MAIN LT PANEL

B	NAME	DATE	MFG.BY:AMIT PROJECT & CONTROLS KOLKATA (CPRI TESTED)	CLIENT: DURGAPUR POWER	PROJECT- Construction of Proposed Up-gradation of Rural Hospital to 100 bedded State General Hospital along with Residential Officers / Staff Quarters at Santiniketan, in the district of Birbhum	DRG. NO. APC022/DP/4733
A	CHECKED	P.K.B	15.11.2022	For DURGAPUR POWER CONTRACTOR <i>Mamun Ali</i>	SHEET: 3 OF 3	TOTAL SHEET: 3
C	APPROVED	N.D	15.11.2022	8 PAGLADANGA ROAD,KOL-105	TITLE: MAIN LT PANEL	SCALE: NOT TO SCALE REV.-3 DATE: REV.-2 DATE: REV.-1 DATE: REV.-0 DATE:

PROJECT- Construction of Proposed Up-gradation of Rural Hospital to 100 bedded State General Hospital along with Residential Officers / Staff Quarters at Sainthia, in the district of Birbhum

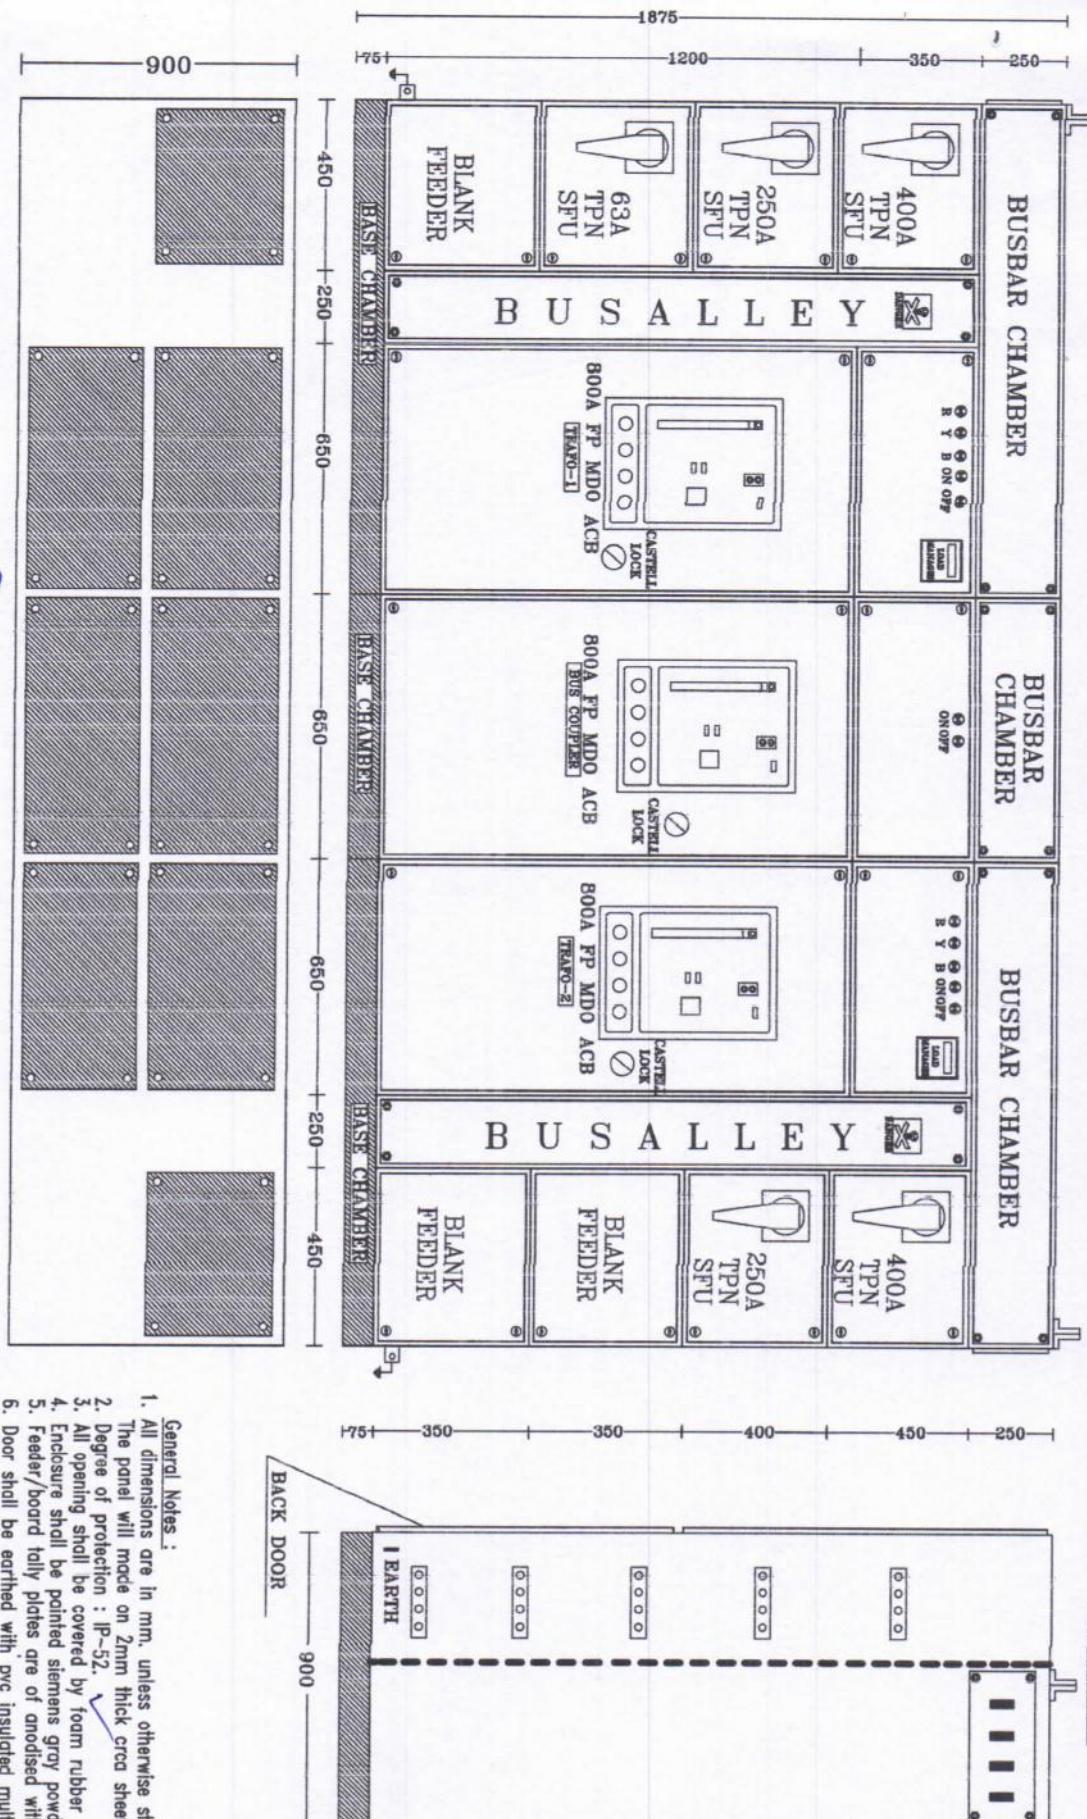
*Should be Copper of
Same dimension*

Same dimension

MFG.BY:AMIT PROJECT & CONTROLS		CLIENT:	DURGAPUR POWER	
DRAWN	S.GOSWAMI 15.11.2022	DURGAPUR POWER	For DURGAPUR POWER	Assistant Engineer PWD
CHECKED	P.K.B 15.11.2022			Electrical Sub-Division
APPROVED	N.D 15.11.2022		CUBICAL TYPE LT PANEL-2

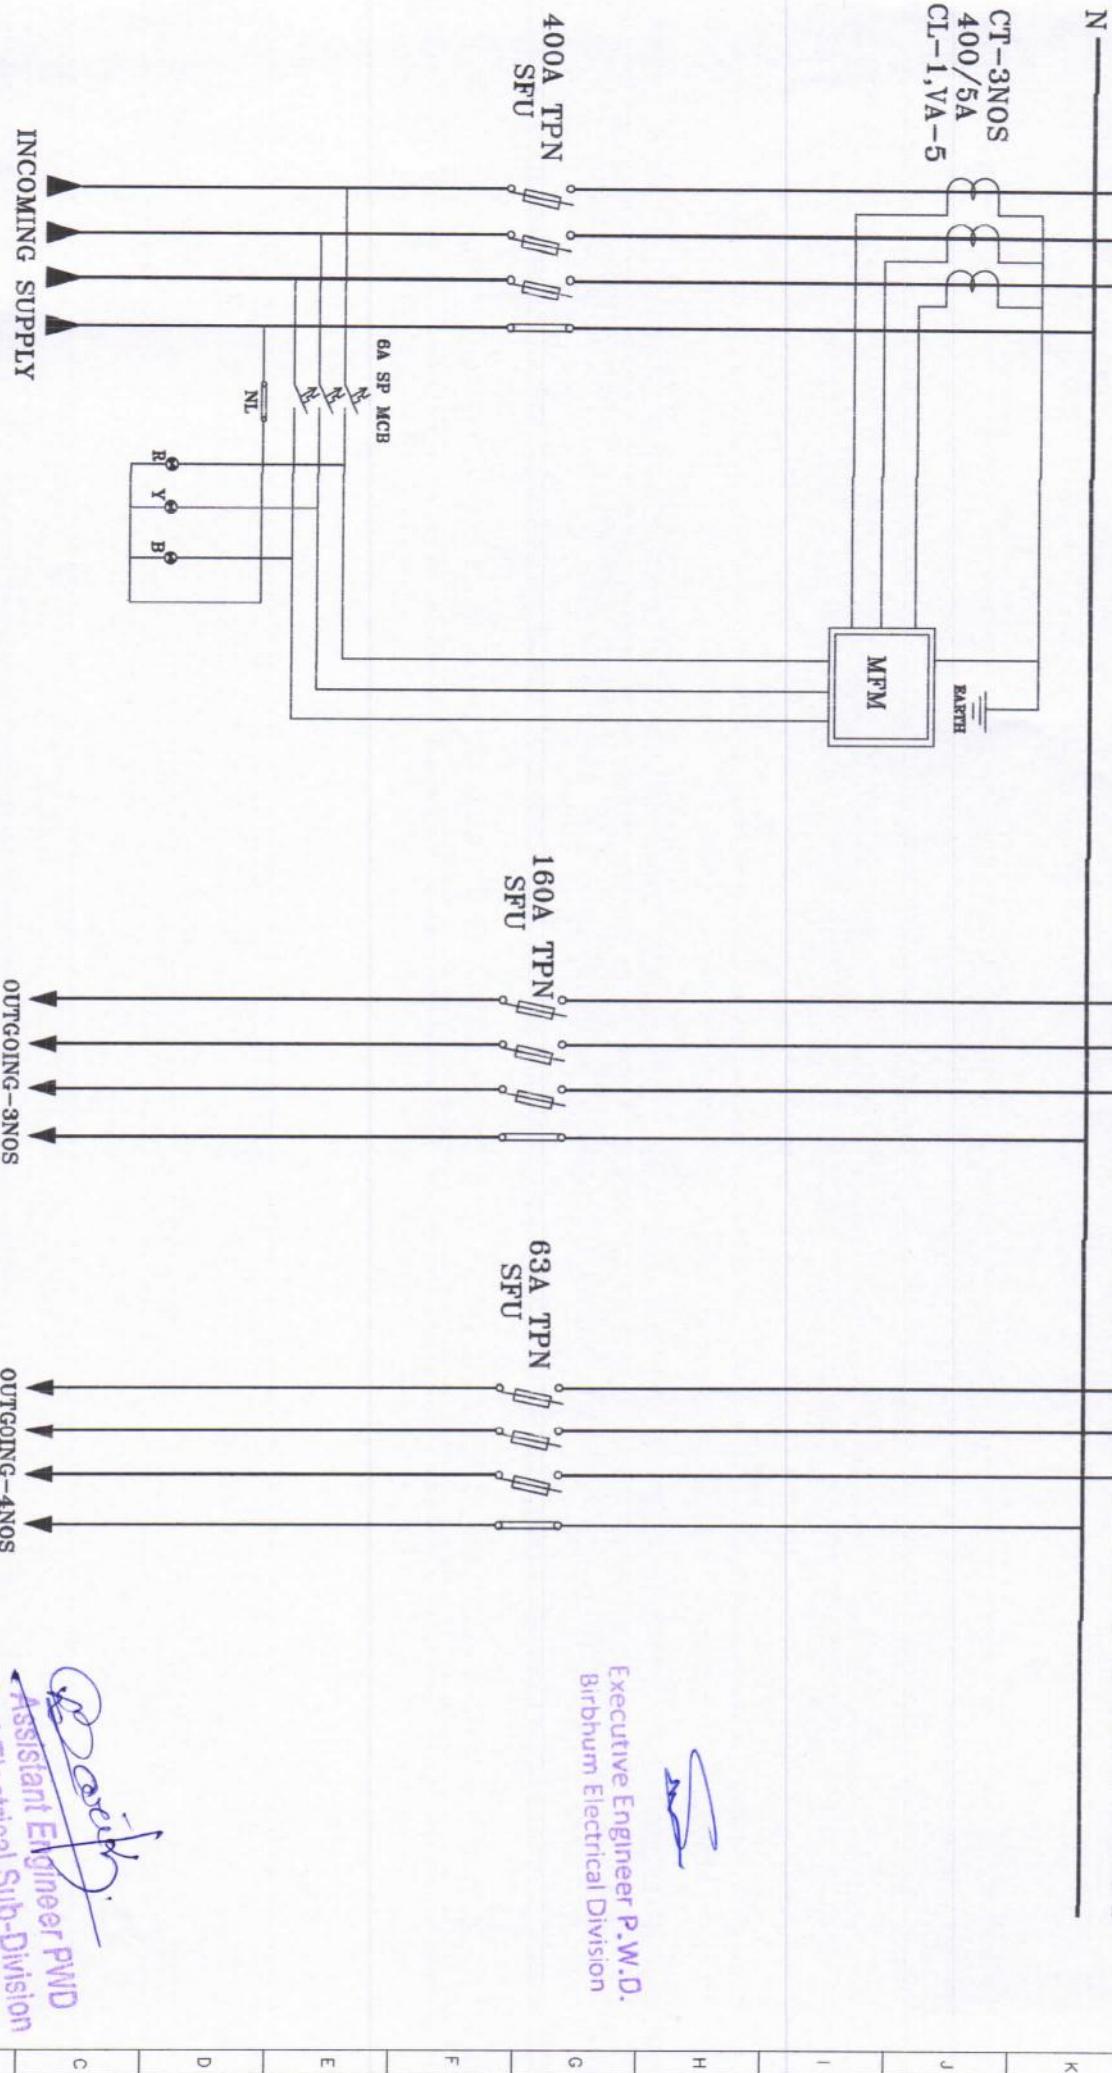
CUBICAL TYPE LT PANEL-2			
		TOTAL QTY.	MAKER'S NAME
1	INCOMER FEEDER	1	NOS
1	400A TPN SFU WITH HRC	1	L&T
2	MULTIFUNCTION METER	1	L&T
3	LED INDICATION LAMP (R/Y/B) with <i>Toggle scatter</i> <i>Control for over indication lamp.</i>	1	SET ESSEN/ESBE E
4	CT 400/5A CL-1, VA-5 TAPE WOUND TYPE	3	NOS KAPPA
5	6A SP MCB <i>Justified rated some breaker</i>	3	NOS L&T
	OUTGOING FEEDER		
1	160A TPN SFU WITH HRC	3	NOS L&T
2	63A TPN SFU WITH HRC	4	NOS L&T

CUBICAL TYPE LT PANEL-3

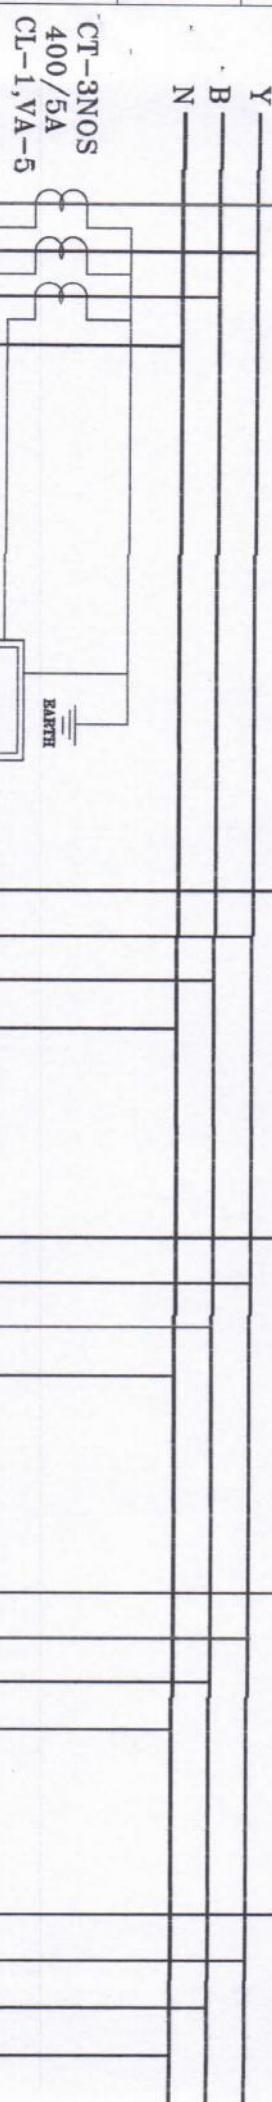
TOTAL QTY.	MAKER'S NAME
	INCOMER FEEDER		
1	400A TPN SFU WITH HRC	1 NOS	L&T
2	MULTIFUNCTION METER	1 NOS	ESSEN/ESBE E
3	LED INDICATION LAMP (R/Y/B) with Toggle switch <i>Control for every indication lamp.</i>	1 SET	
4	CT 400/5A CL-1, VA-5 TAPE WOUND TYPE	3 NOS	KAPPA
5	6A SP MCB Justified rated SpMCB is required	3 NOS	L&T
	OUTGOING FEEDER		
1	250A TPN SFU WITH HRC	2 NOS	L&T
2	160A TPN SFU WITH HRC	2 NOS	L&T
3	100A TPN SFU WITH HRC	2 NOS	L&T
4	32A TPN SFU WITH HRC	1 NOS	L&T

CUBICAL TYPE LT PANEL-4

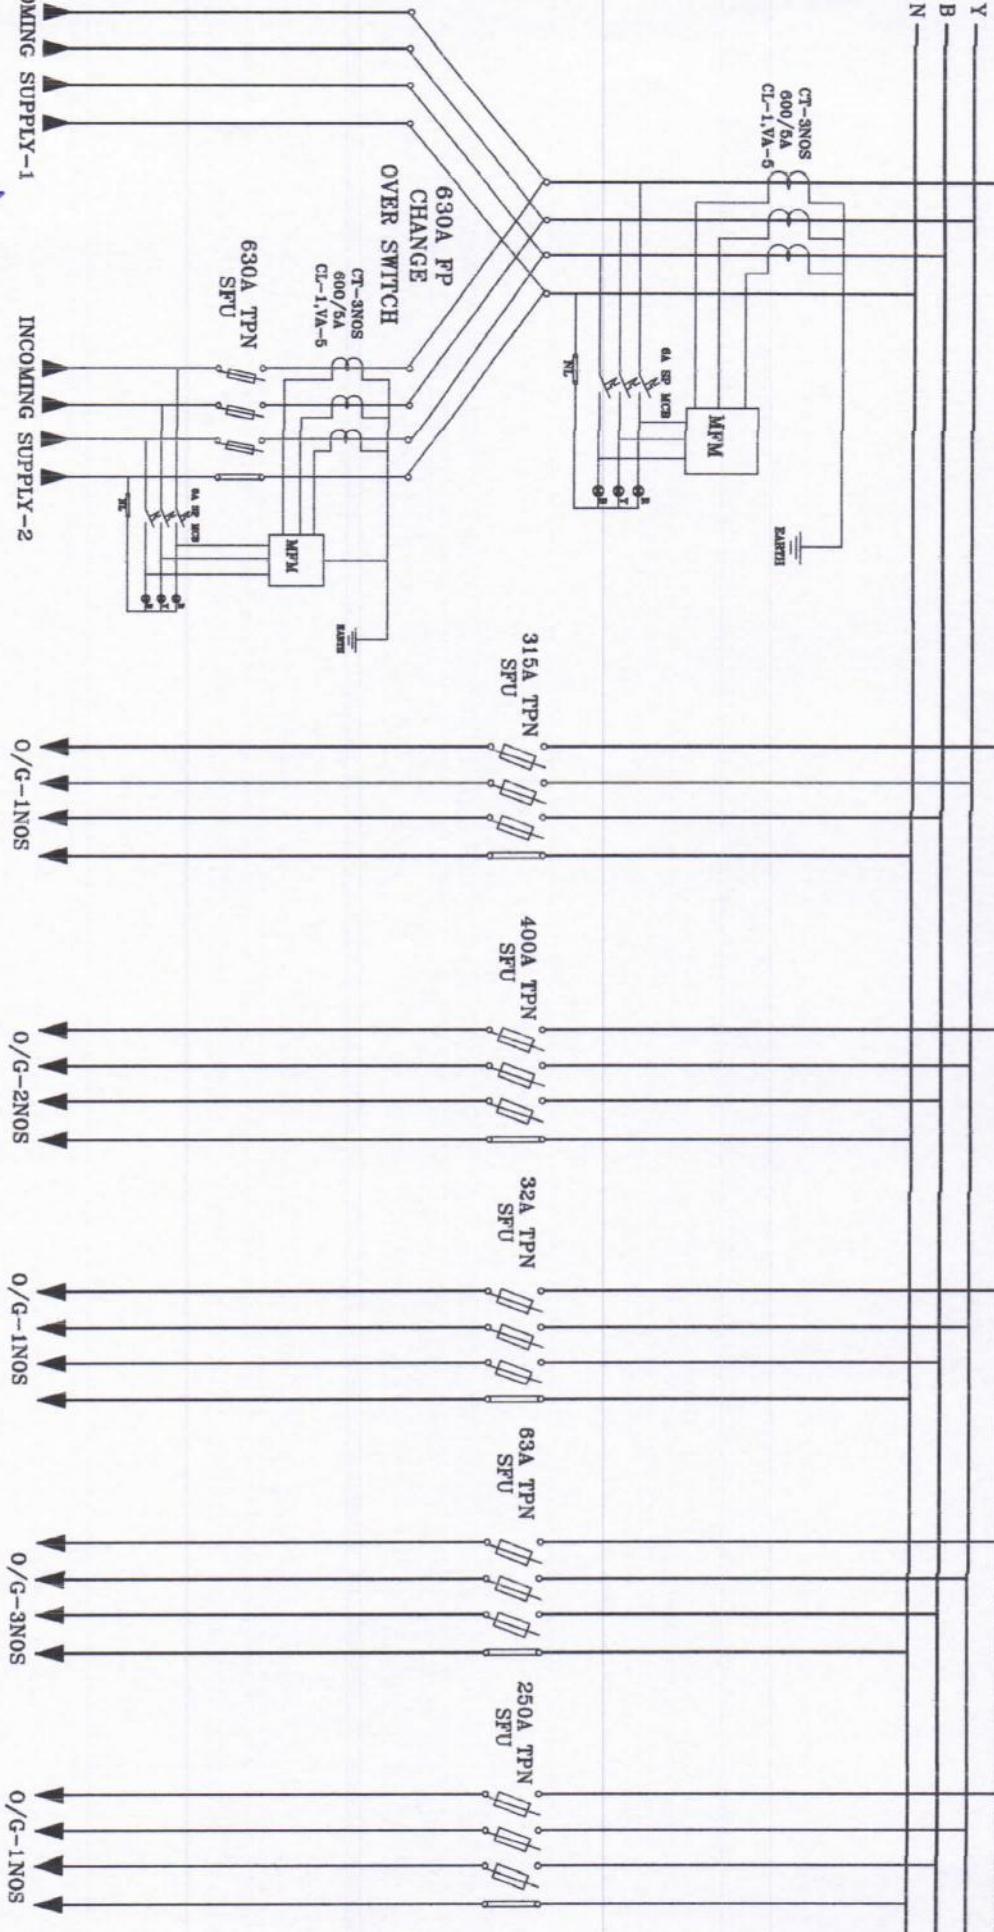
INCOMER FEEDER			TOTAL QTY.	MAKER'S NAME
1	630A TPN SFU WITH HRC		1	NOS L&T
2	MULTIFUNCTION METER		2	NOS L&T
3	LED INDICATION LAMP (R/Y/B) with toggle Switch Control for energy indication Lamp.		6	NOS ESSEN/ESBE E
4	CT 600/5A CL-1, VA-5 TAPE WOUND TYPE		6	NOS KAPPA
5	6A SP MCB <i>(Intended rated ampere is removed)</i>		6	NOS L&T
6	630A 4P ON LOAD CHANGEOVER SWITCH		1	NOS L&T
OUTGOING FEEDER				
1	315A TPN SFU WITH HRC		1	NOS L&T
2	400A TPN SFU WITH HRC		2	NOS L&T
3	32A TPN SFU WITH HRC		1	NOS L&T
4	63A TPN SFU WITH HRC		3	NOS L&T
5	250A TPN SFU WITH HRC		1	NOS L&T

Corected by Assistant Engineer PWU
